# GLASTAR SERVICE BULLETIN 37

## MANDATORY

**Subject:** Aileron cable interference

**Applicability:** All GlaStar kits shipped prior to the publication of *GlaStar Assembly Manual* Revision D

Figure 1: Possible Aileron Cable Interference

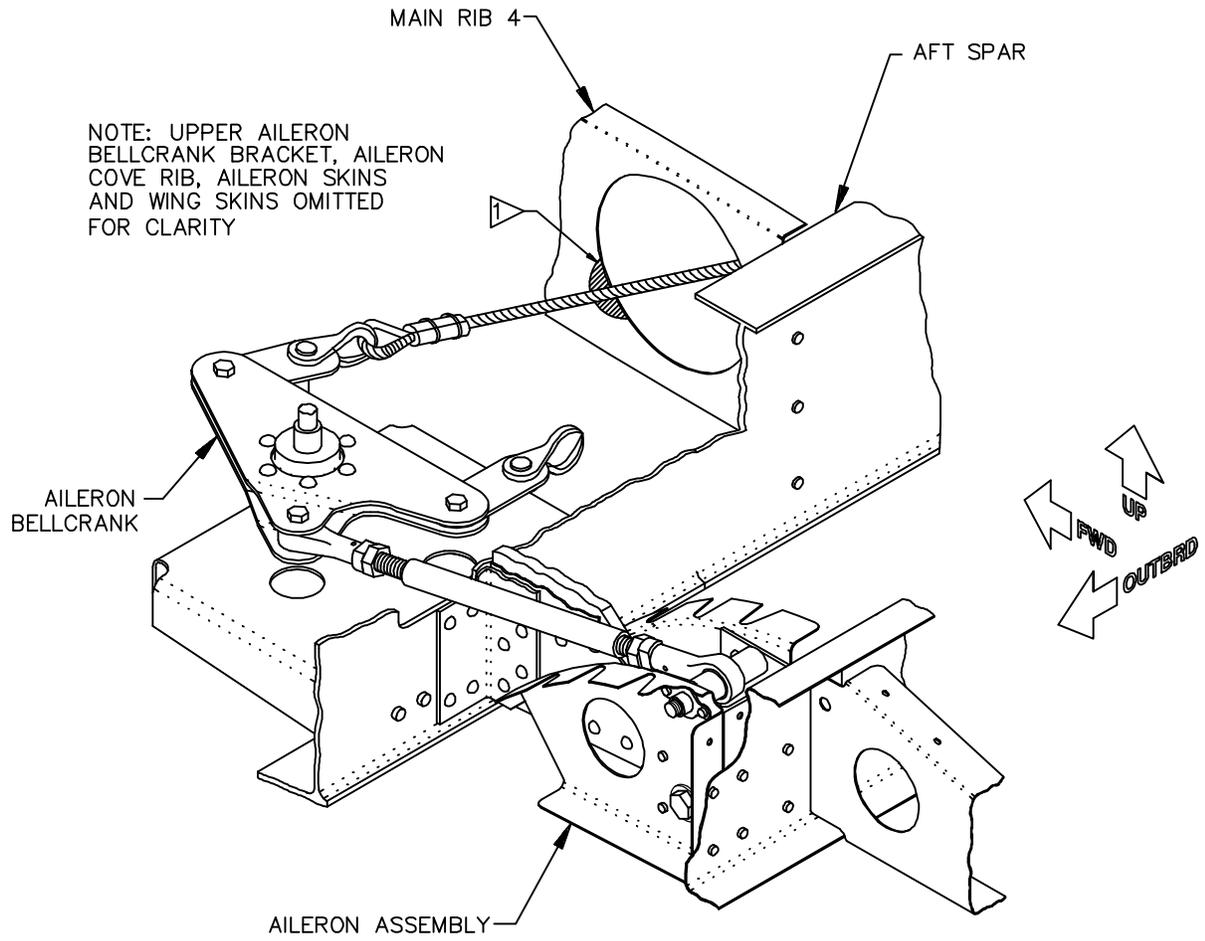
**Discussion:** It has come to our attention that interference may exist between the crimped NicoPress sleeve at the outboard end of each aileron crossover cable and the forward edge of the aftmost lightening hole in Main Rib 4. Because this interference is slight and is likely to occur only at the extreme up aileron position, it is easy to miss on initial rigging and even on later inspection of the completed installation. However, any interference between control cables and the airframe is unacceptable and must be corrected.

Remove the inspection hole covers under the aileron bellcranks on both wings. While an assistant moves the stick from one extreme of aileron travel to the other, use a flashlight to inspect for interference between Main Rib 4 and the cable coming off the **forward** arm of the bellcrank. (See Flag 1 in Figure 1.) There should be no contact whatsoever at any point in the aileron travel between the rib and the cable or the NicoPress sleeve. If no interference is found, no further action is required.

If interference is discovered, the solution is simply to relieve the rib web at the forward edge of the aftmost lightening hole to eliminate the interference. As indicated by the shaded area in Figure 1, use a file or a grinder to cut away a crescent-shaped piece of the rib web as necessary to allow complete clearance for the cable and NicoPress sleeve. Smooth the cut edges.
